Rampion 2 Wind Farm

Applicant's Response to Non- Prescribed Consultees' Written Representations

Date: March 2024
Rev A

Application Reference: 8.53
Pursuant to: The Infrastructure Planning (Examination
Procedure) Rules 2010, Rule 8(1)(c)(i)
Ecodoc number: 005131278-01

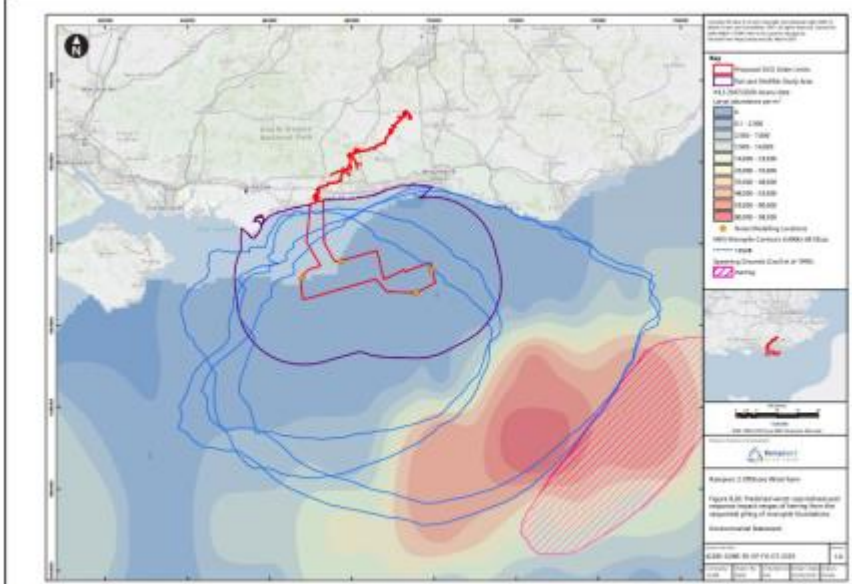
2.1.50	The maximum might be around -25 dB with a combination of mitigation devices, this is still way off. At these levels more modelling should be done to evidence not just mitigation specifics which are lacking but also legitimate capability to achieve levels set out as the defined minimum by the MMO.	It is beyond the scope of this response to explain underwater acoustics, but there is no expectation that a reduction of over 100 dB(A) re 1 µPa would or should be achieved. 135 dB is not a defined minimum set out by the MMO, but a recommendation. The Applicant highlights it has committed to and secured a number of noise mitigation measures within the application. This includes the Draft Piling Marine Mammal Mitigation Protocol [APP-236] secured via Schedule 11, Part 2 11 (l) and Schedule 12, Part 2 11 (l) of the Draft Development Consent Order [PEPD-009] included in Table 8-13 of Chapter 8: Fish and shellfish ecology, Volume 2 of the ES [APP-049] which is an embedded environmental measure related to the use of soft start procedures for piling to deter mobile marine life, therefore reducing the noise exposure to fish and shellfish receptors when assessed as mobile receptors. With regards to mitigating against the potential for impacts to sensitive stationary receptors such as black seabream and seahorse, further mitigation measures have been proposed. These are detailed in the In Principle Sensitive Features Mitigation Plan [REP1-012] and include the implementation of at least one noise mitigation technology year-round. These measures are secured via Schedule 11, Part 2 11 (k) and Schedule 12, Part 2 11 (k) of the Draft Development Consent Order [PEPD-009] .

The Applicant has investigated the use of various underwater noise mitigation technologies and provided underwater modelling outputs for the implementation of noise abatement measures, used both singly and in-combination, to ensure the Conservation Objectives of the Kingmere MCZ will not be hindered in the In Principle Sensitive Features Mitigation Plan [APP-239] . This document sets out details of the equipment and techniques currently available to provide certainty that reductions in noise emissions, and importantly immissions at receptor sites, can be delivered. However, it is important that developments in the field of noise abatement are not excluded from use at the Proposed Development. It is on this basis that the Applicant considers the mitigation specifics provided at this time to be appropriate, both reflecting the secured

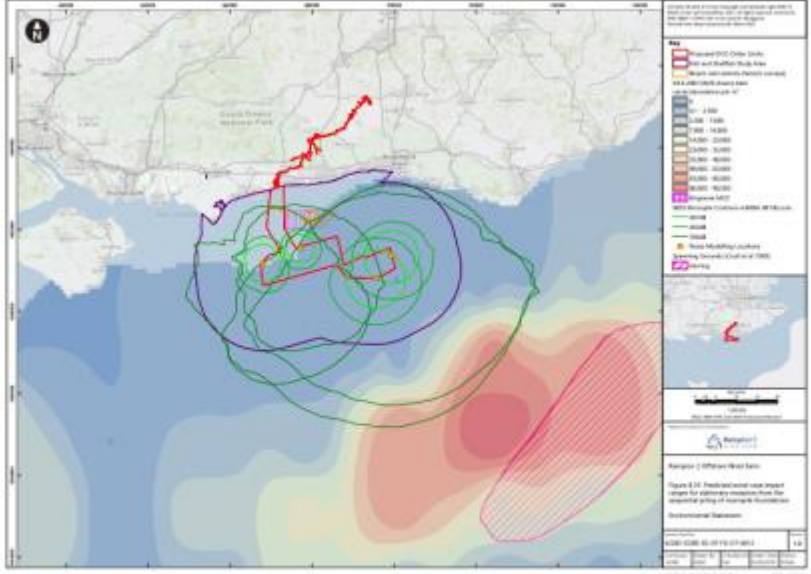
2.1.52	<p>Sussex Wildlife Trust have also asked for a commitment on noise abatement technology. - 4.6.65 "To summarise MMO has major concerns outstanding and considers further information is required on modelling along with further discussions on mitigation.</p>	<p>Noted, the Applicant has no further comments on this matter at this time.</p>
